Refer to: HSA-10/WZ-130

Thank you for your letter of June 14, 2002, requesting Federal Highway Administration (FHWA) acceptance of your company's X-CELL 48 HDL tall portable sign stands as crashworthy traffic control devices for use in work zones on the National Highway System (NHS). Accompanying your letter was a report of crash testing conducted by E-Tech Testing Services and a video of the tests. You requested that we find these devices acceptable for use on the NHS under the provisions of National Cooperative Highway Research Program (NCHRP) Report 350 "Recommended Procedures for the Safety Performance Evaluation of Highway Features." You provided additional information at our request via a facsimile message on December 12, 2002.

Illustration 1. X-CELL 48 HDL Sign Stand (1 of 1)

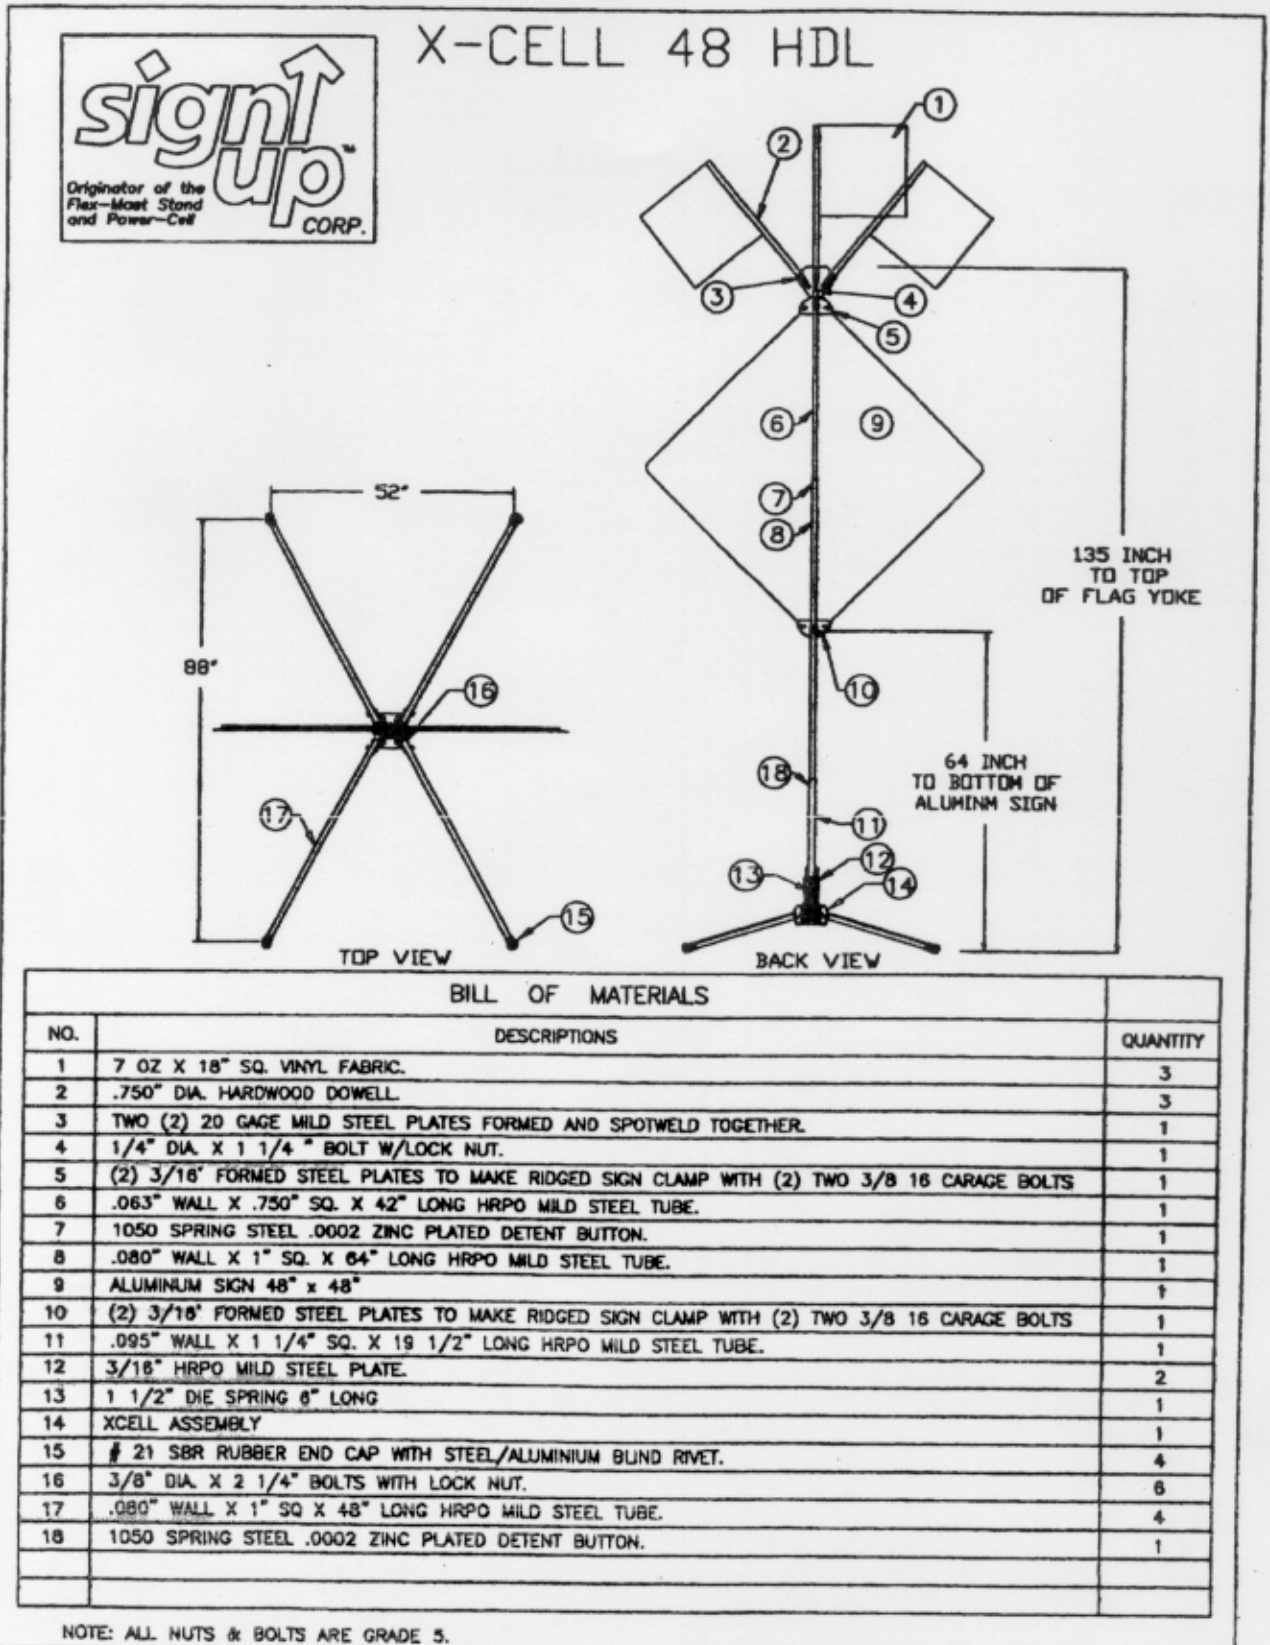
Full-scale automobile testing was conducted on your company’s devices. Two stand-alone examples of the device were tested in tandem, one head-on and the next placed six meters downstream turned at 90 degrees, as called for in our guidance memoranda. The complete device as tested is shown in Enclosure 1. The crash test is summarized in the table below:

Damage was nonexistent in this impact as the mast separated from the base and the sign rotated over the vehicle in both impacts. Velocity changes were well below the maximum and within the “desirable” range. The results of the testing met the FHWA requirements and, therefore, the portable sign stand described above and shown in the enclosed drawings for reference are acceptable for use on the NHS under the range of conditions tested, when proposed by a State.
